Docket No. 50-336  
B14102

Millstone Nuclear Power Station, Unit No. 2  
Proposed Revision to Technical Specifications  
Spent Fuel Pool Reactivity

Proposed Revised Pages

April 1992

SPENT FUEL POOL ARRANGEMENT UNIT #2  
 FIGURE 3.9-2

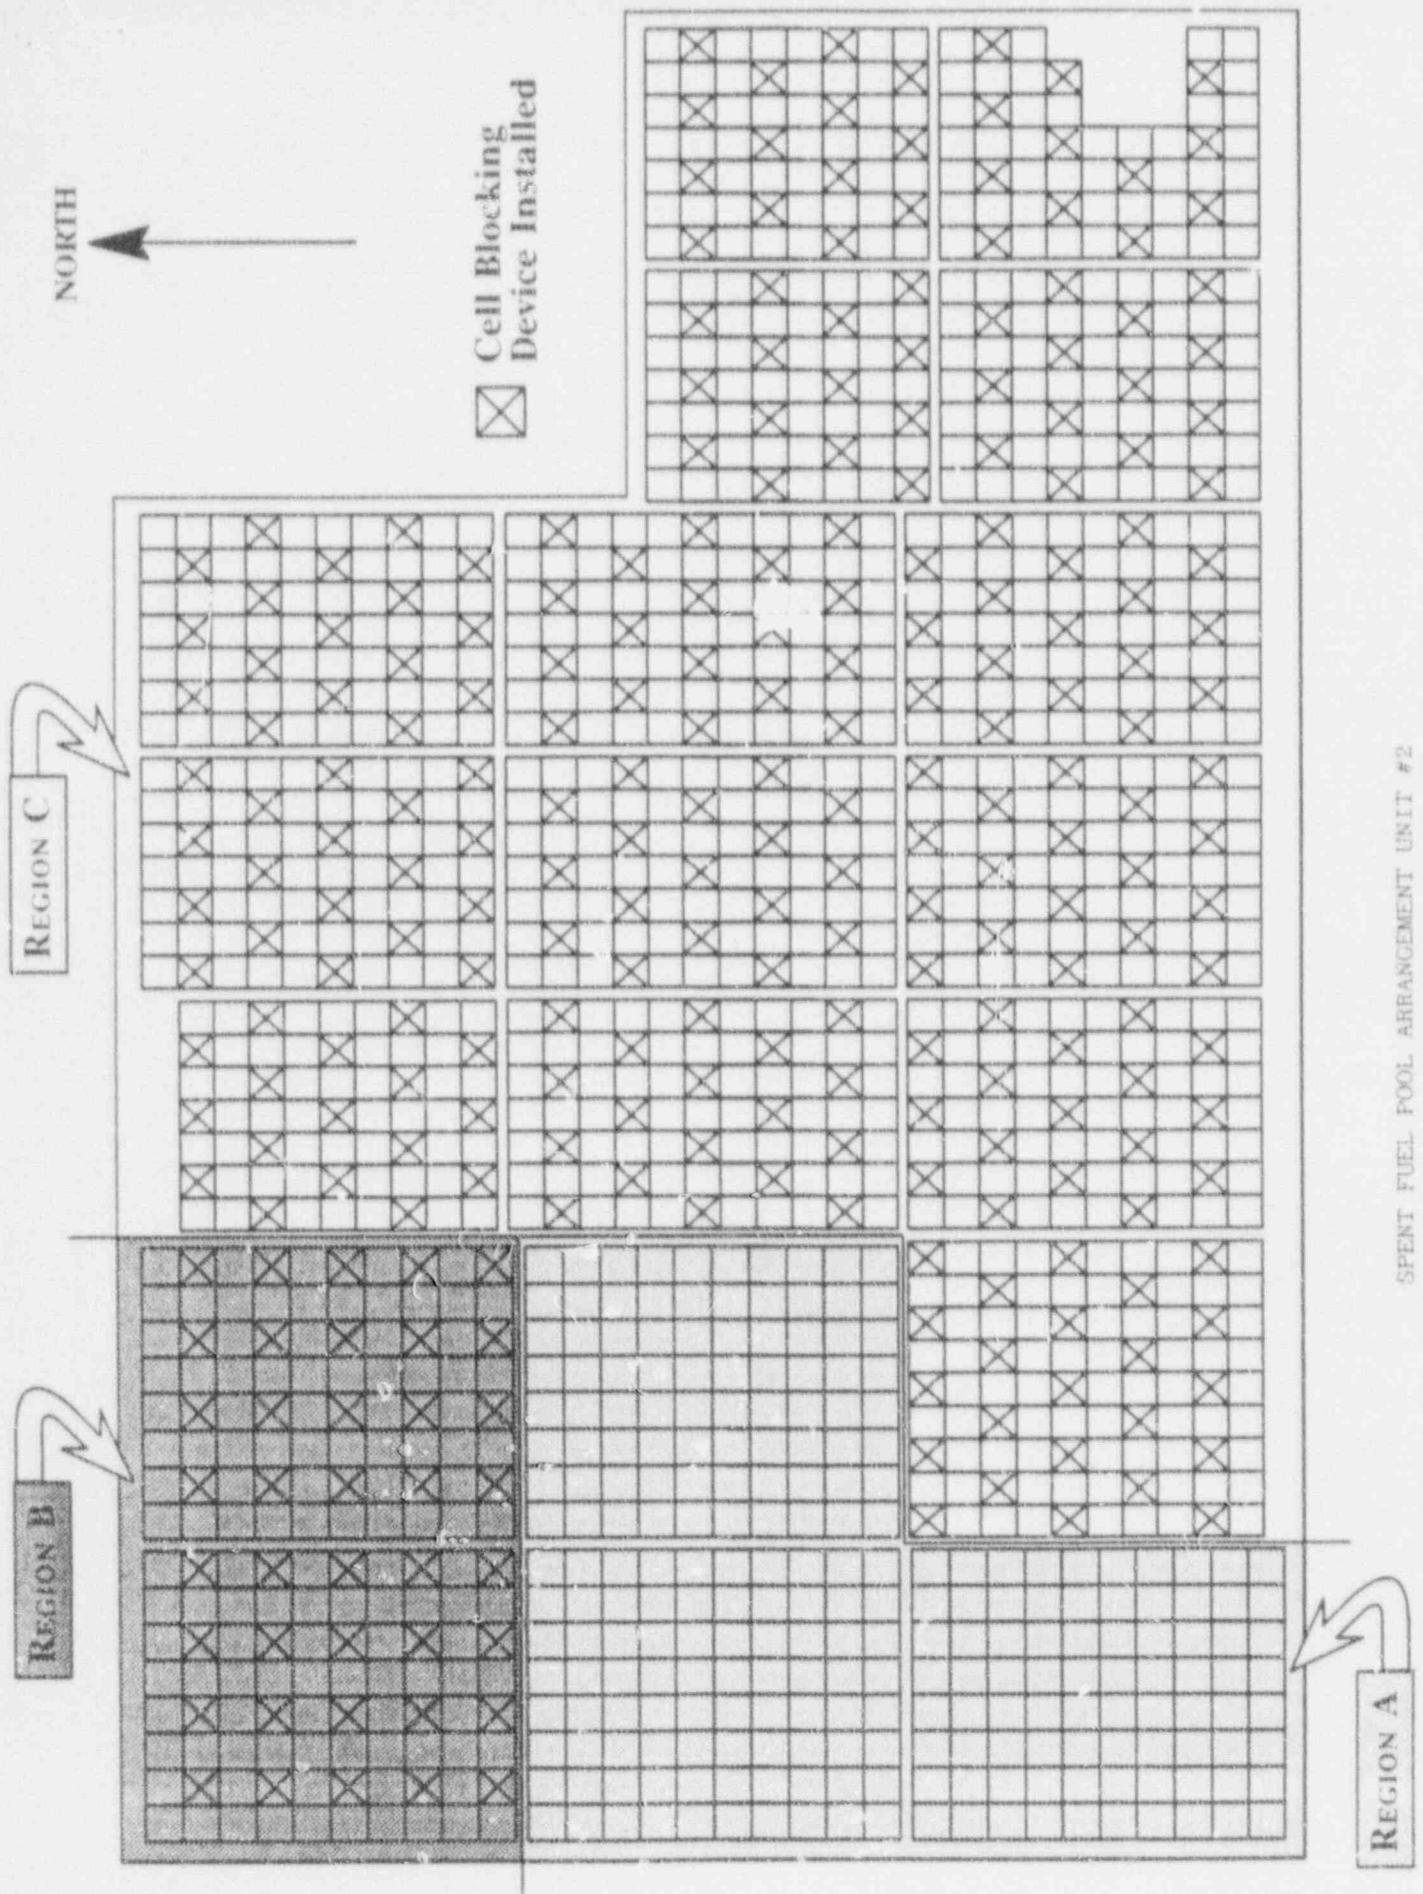
- (1) A cell blocking device is installed in those cell locations shown in Figure 3.9-2; or
- (2) If a cell blocking device has been removed, all cells of the STORAGE PATTERN must have consolidated fuel in them, including the formerly blocked location; or
- (3) Meet both (a) and (b):
  - (a) If a cell blocking device has been removed, all cells of the STORAGE PATTERN must have consolidated fuel in them except the formerly blocked location.
  - (b) The formerly blocked location is vacant and a consolidated fuel box or cell blocking device is immediately being placed into the formerly blocked cell.

- (1) A cell blocking device is installed in those cell locations shown in Figure 3.9-2; or
- (2) If a cell blocking device has been removed, all cells in the STORAGE PATTERN must be vacant of stored fuel assemblies.

Calculations were also made to determine if there might be any adverse reactivity effects along the interface between regions. Even without credit for the isolating water-gap between modules, no adverse effects were found for any of the interfaces--Regions A and B, Regions A and C, and Regions B and C (see Figure 3.9-2 in Technical Specifications). Region C is the old Region II, designed for burned fuel.

FIG. 3.9-4 MINIMUM REQUIRED FUEL ASSEMBLY EXPOSURE AS A FUNCTION OF INITIAL ENRICHMENT TO PERMIT STORAGE IN REGION A

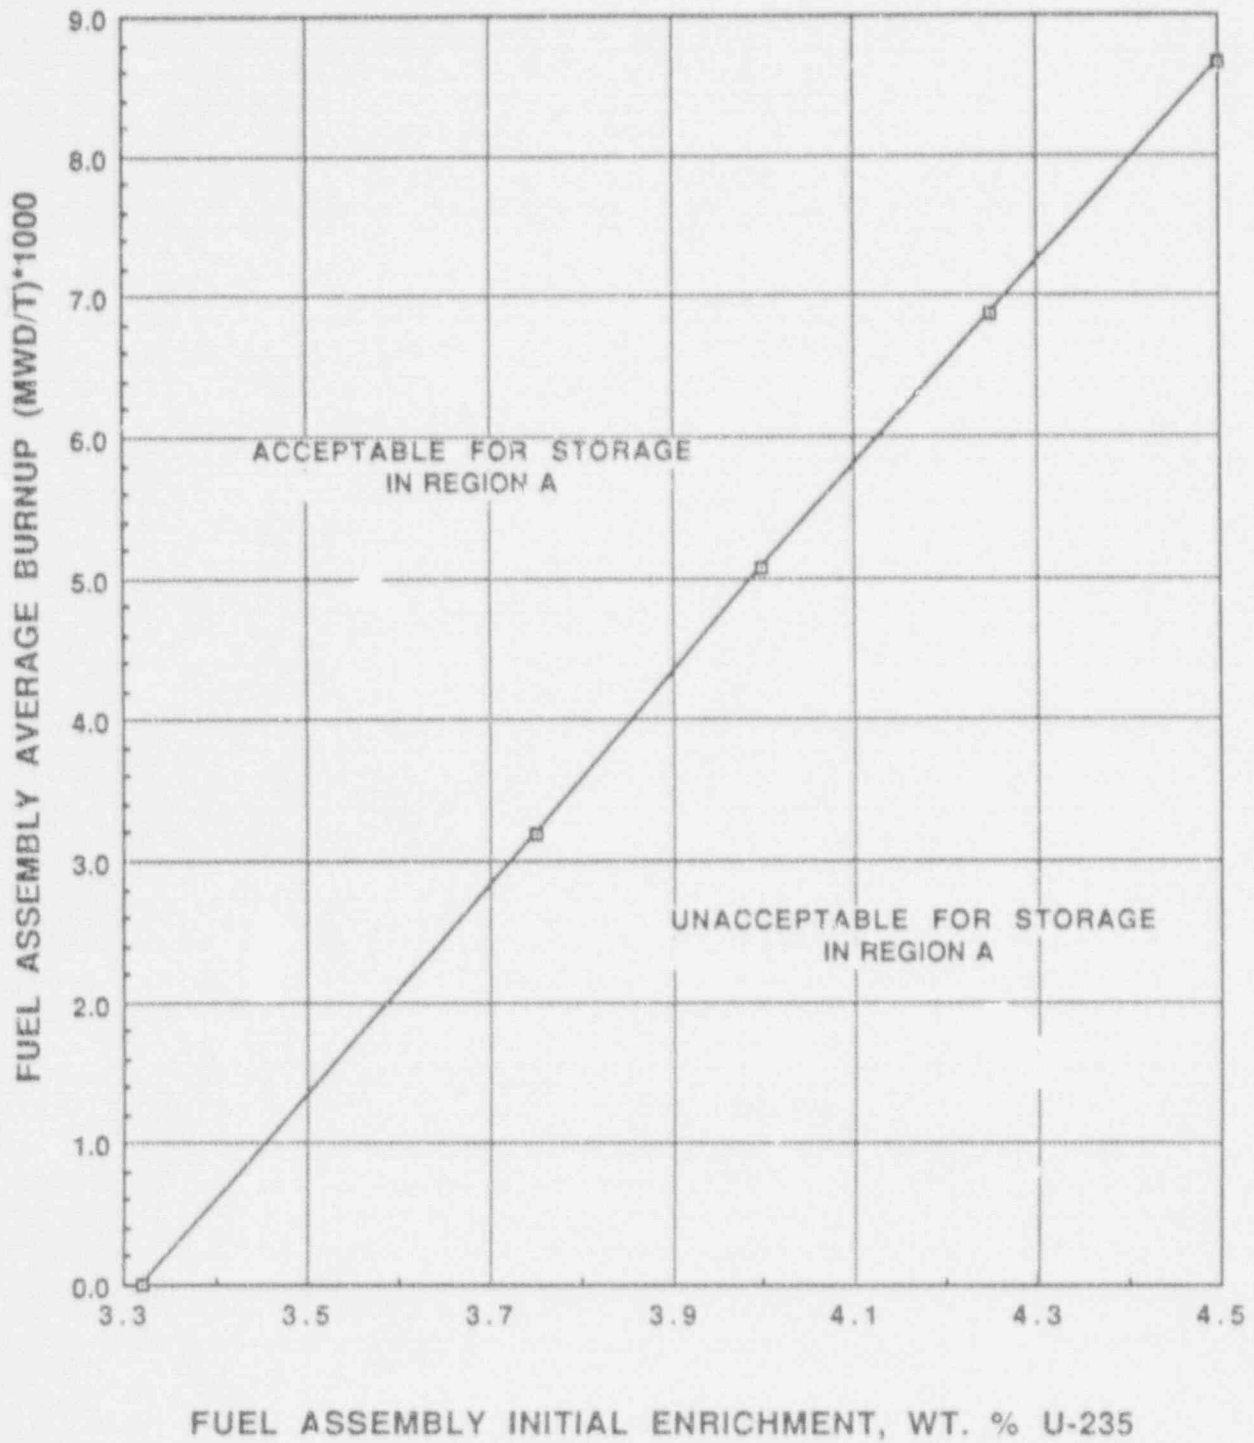
4.9.18.3 Ensure that all fuel assemblies to be placed in Region A (as shown in Figure 3.9-2) of the spent fuel pool are within the enrichment and burnup limits of Figure 3.9-4 by checking the assembly's design and burnup documentation.

The limitations described by Figure 3.9-4 ensure that the reactivity of the fuel assemblies, introduced into the Region A spent fuel racks, are conservatively within the assumptions of the safety analysis.

b) Region A of the spent fuel storage pool is designed and shall be maintained with a nominal 9.8 inch center to center distance between storage locations to ensure a  $K_{eff} \leq .95$  with the storage pool filled with unborated water. Fuel assemblies stored in this region must comply with Figure 3.9-4 to ensure that the design burnup has been sustained.
